July 17, 2012

The Department has received and reviewed the U.S. Nuclear Regulatory Commission's May 21-25, 2012, draft Integrated Materials Performance Evaluation Program report for the South Carolina Agreement State Program. The following are our comments addressing the technical and clerical accuracy of the report:

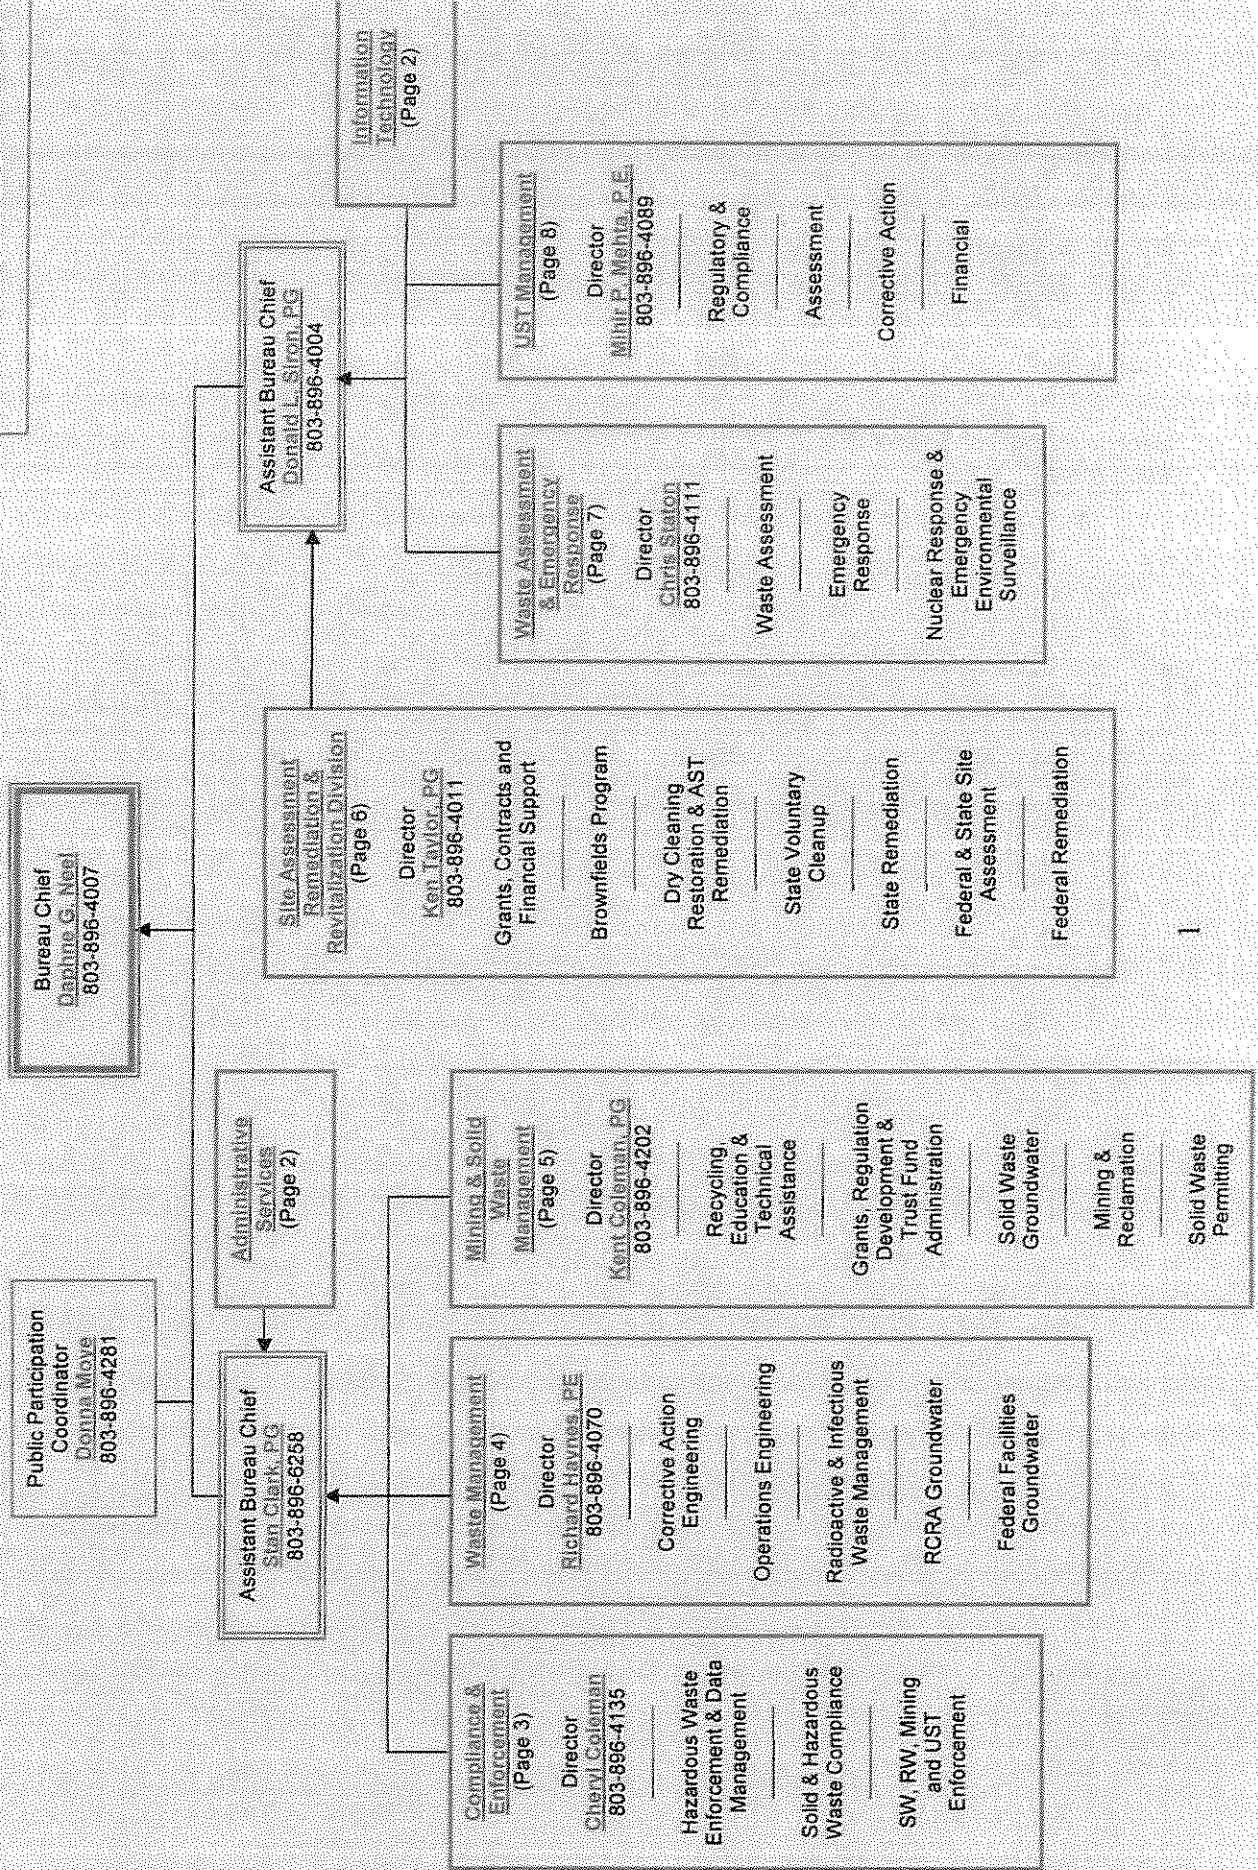
2. Page 1 and Appendix B: The appendix did not include the organization chart for the Division of Land and Waste Management, Low-level Radioactive Waste Program.
